# Monthly Specification Update

**Intel® Server Board S5520UR**

*Intel Order Number E69054-001*

**Sep 2011**

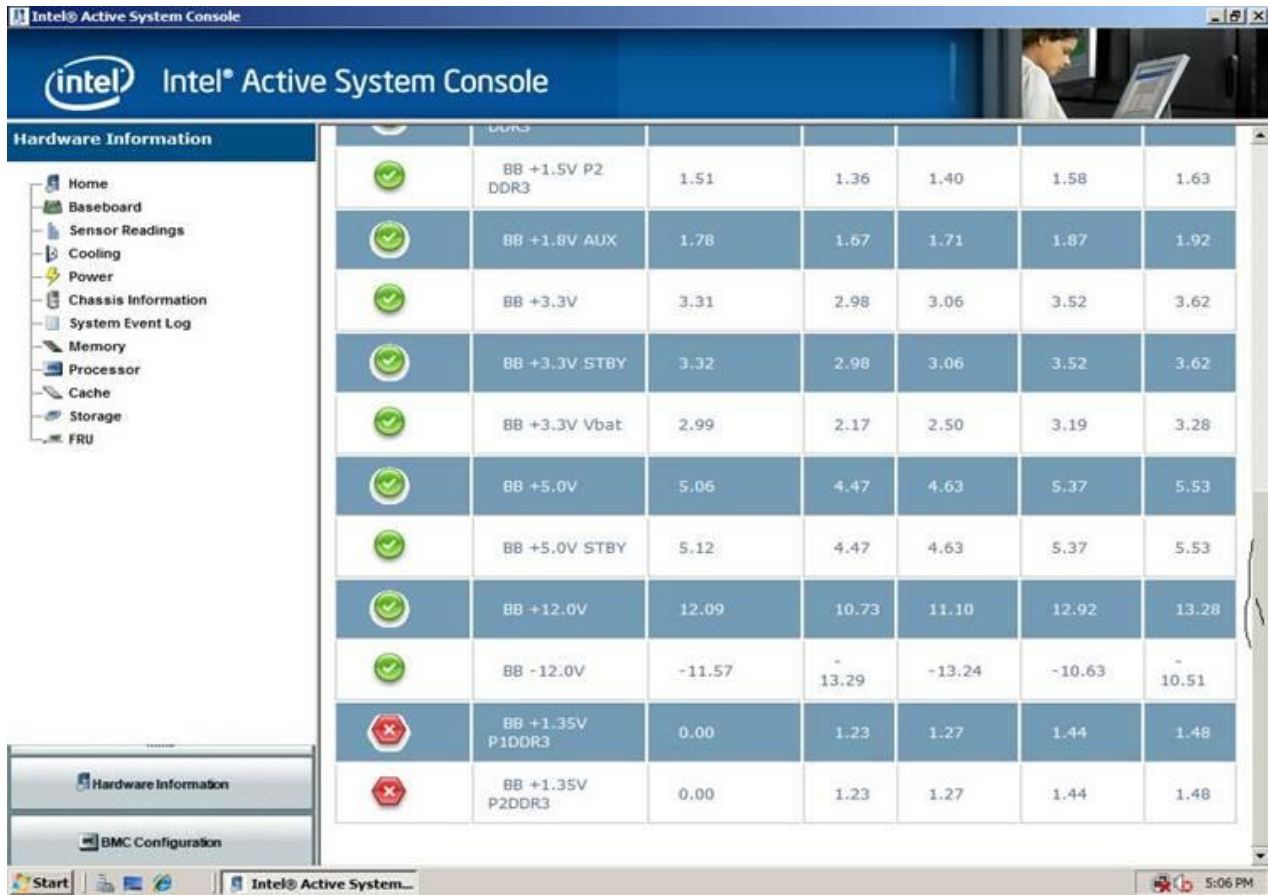
Problem	<p>Intel® Active System Console (IASC) v3.5.1 and v3.5.2 is used to monitor hardware status on Intel server system.</p> <p>Intel® Server Board S5520UR start to support low voltage memory DIMM, so current FRUSDR has contained four memory voltage sensors "BB+1.5v P1DDR3", "BB+1.5v P2DDR3", "BB+1.35v P1DDR3" and "BB+1.35v P2DDR3", When system has 1.5v memory or 1.35v memory, only corresponding memory voltage sensors will be enabled, the other type memory voltage sensors will be disabled.</p> <p>IASC cannot judge the status of memory voltage sensors which have been disabled, and still try to detect those sensors reading. Because sensor reading is "0", lower than its threshold, so IASC shows those sensors status as critical warning.</p> <p>Below is screen shoot of this failure</p>
---------	--

**Implication** IASC fails to judge the status of disabled sensors and still considers those sensors to server health algorithm.

**Status** This issue will be fixed on next IASC release.

**Figure 1. Removing the Heatsink**

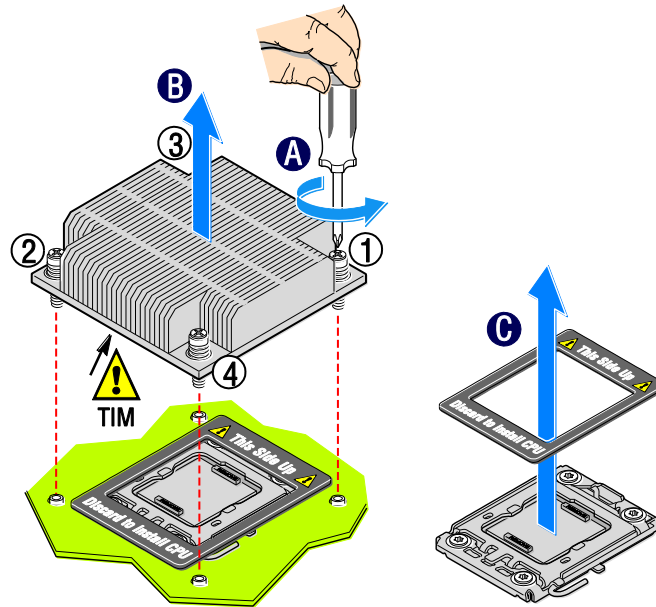
**Problem:** The current documentation does not properly describe the installation and removal of the heatsink. Careful insertion and removal of the heatsink is required to prevent damage to the heatsink screws or backplate.

**Implication:** There is a possibility of damage to the heatsink if proper steps are not followed.

1. Loosen the four captive screws on the heatsink corners in a diagonal manner according to the numbers shown in figure 1 as follows:
  - Starting with the screw at location 1, loosen it by giving it **two rotations** in the anticlockwise direction and stop. (**IMPORTANT:** Do not fully loosen.)
  - Proceed to the screw at location 2 and loosen it by giving it two rotations and stop.
  - Loosen screws at locations 3 and 4 by giving each screw two rotations and then stop.
  - Repeat steps 1a through 1c by giving each screw two rotations each time until all screws are loosened.
2. Do one of the following:
  - If removing the heatsink for the first time, do the following:
    - i. Lift the heatsink from the board.
    - ii. Remove and discard the spacer (see letter “C” in figure 1).

- If a processor is already installed, do the following:
  - i. Twist the heatsink slightly to break the seal between the heatsink and the processor.
  - ii. Lift the heatsink from the processor. If it does not pull up easily, twist the heatsink again. Do not force the heatsink from the processor. Doing so could damage the processor.
